To: Transportation Commission

From: Ben Zellers and Linda Horvath, West Area Plan Co-Managers

Re: West Area Plan Review and Recommendation

Date: July 31, 2024

Request for Transportation Commission

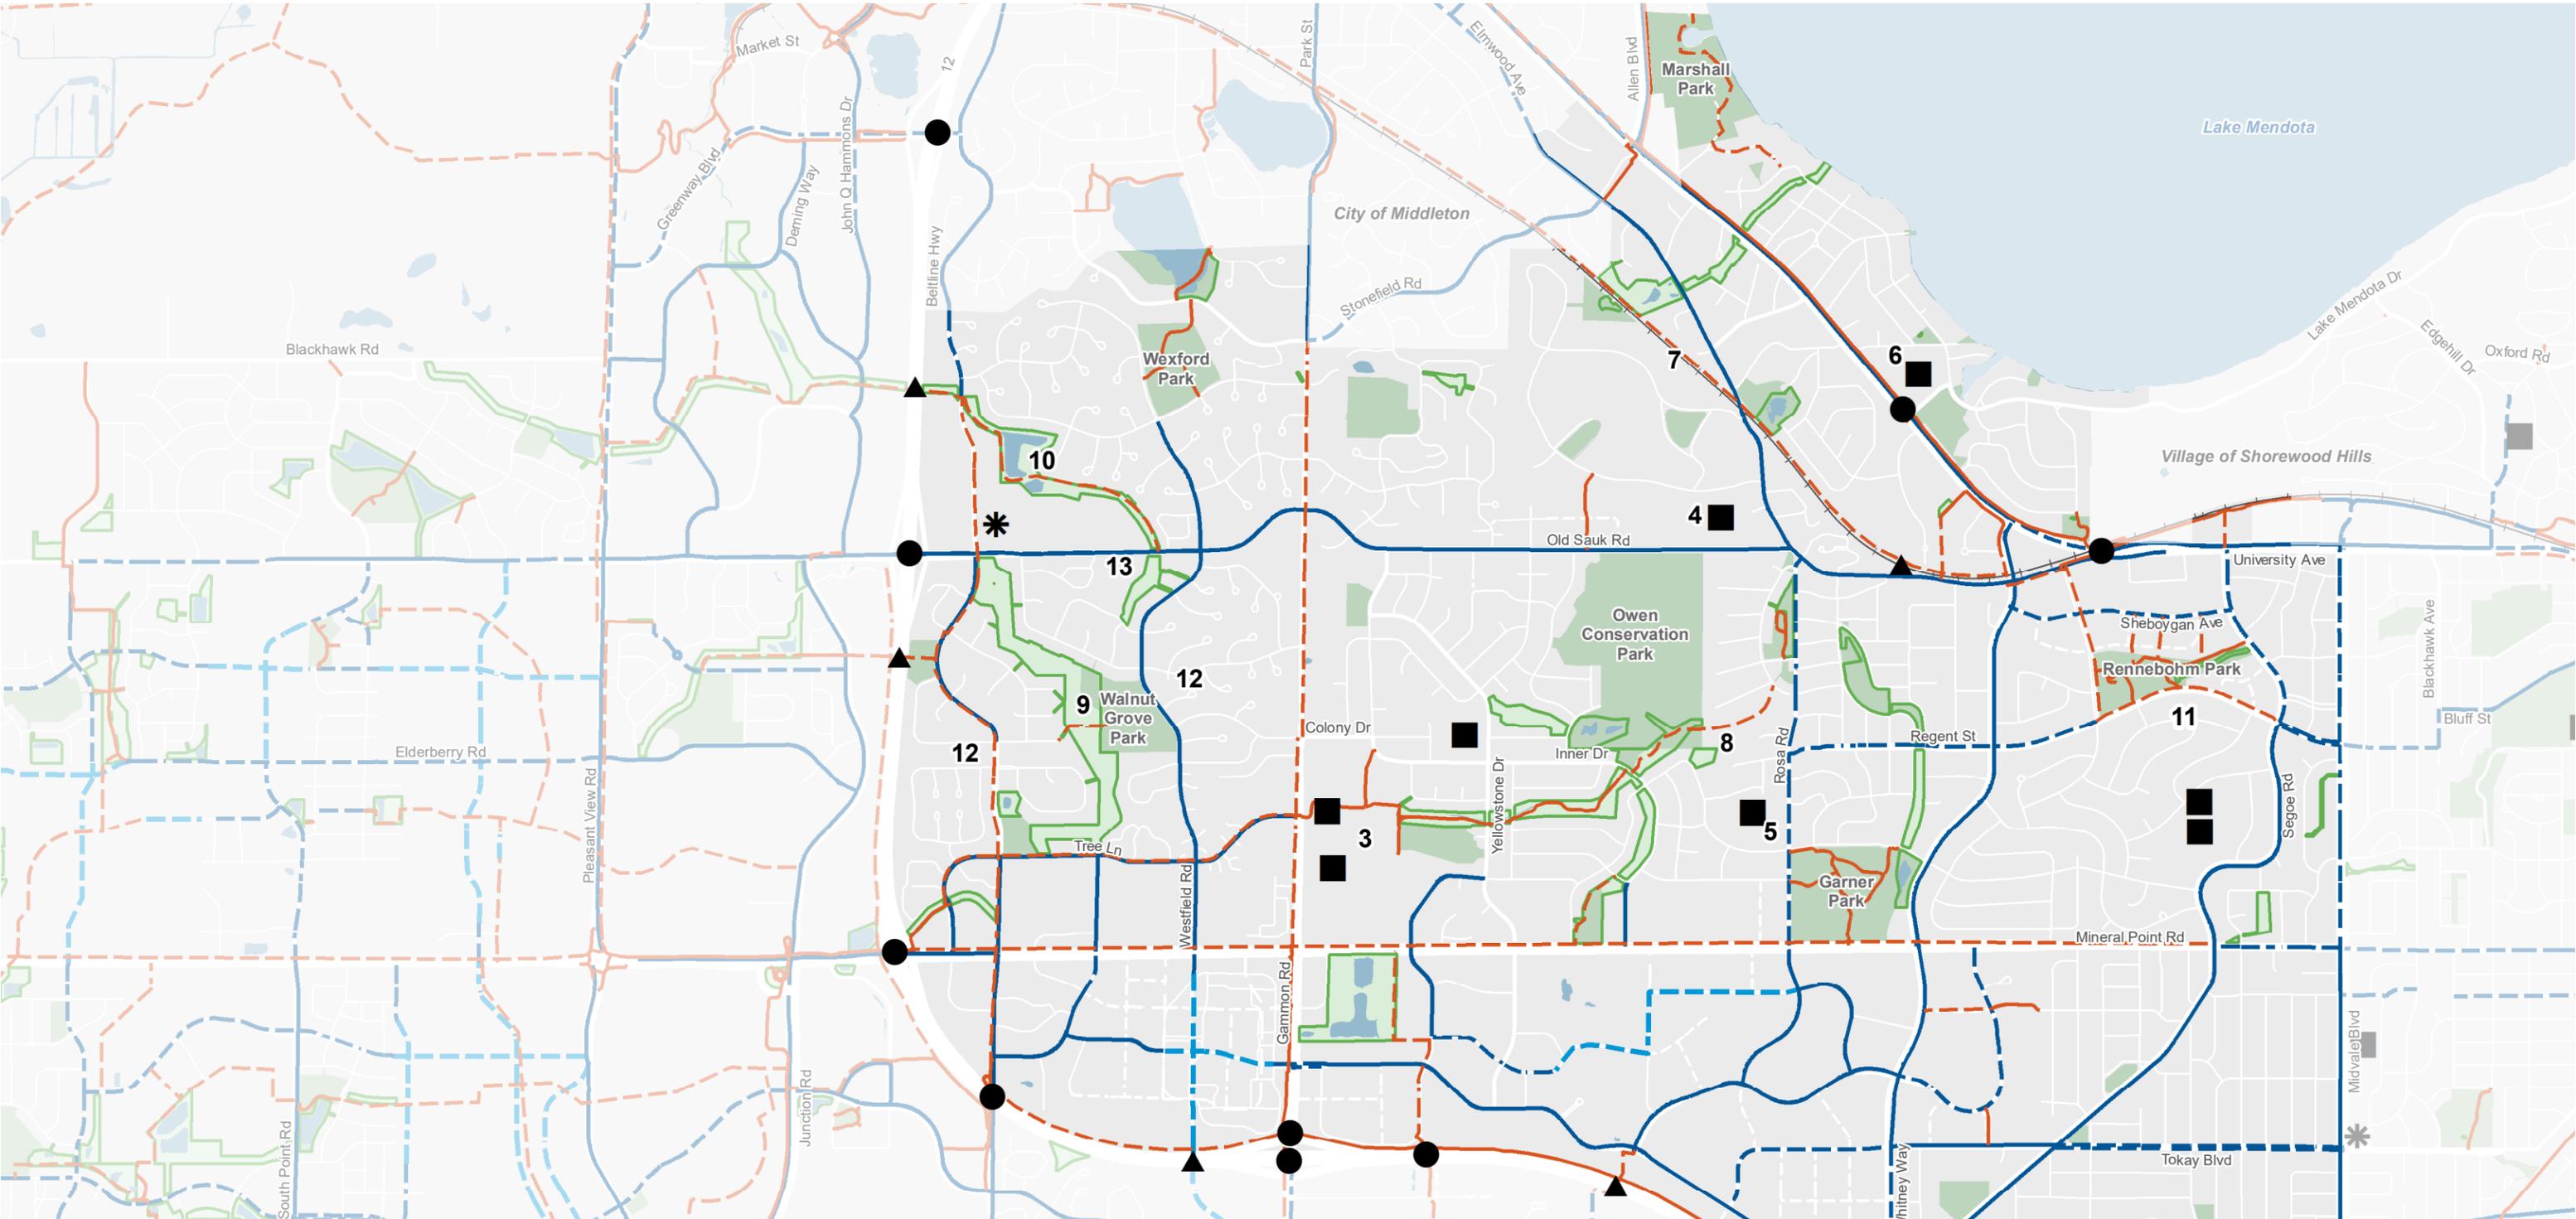
Staff is recommending one transportation-related change to the current draft be made: shifting the connection across the Beltline from Tokay (solid blue line) to the east (dashed blue line). The Wisconsin DOT has conducted additional analysis as part of its [Beltline Study](#), and the eastern connection is more feasible.
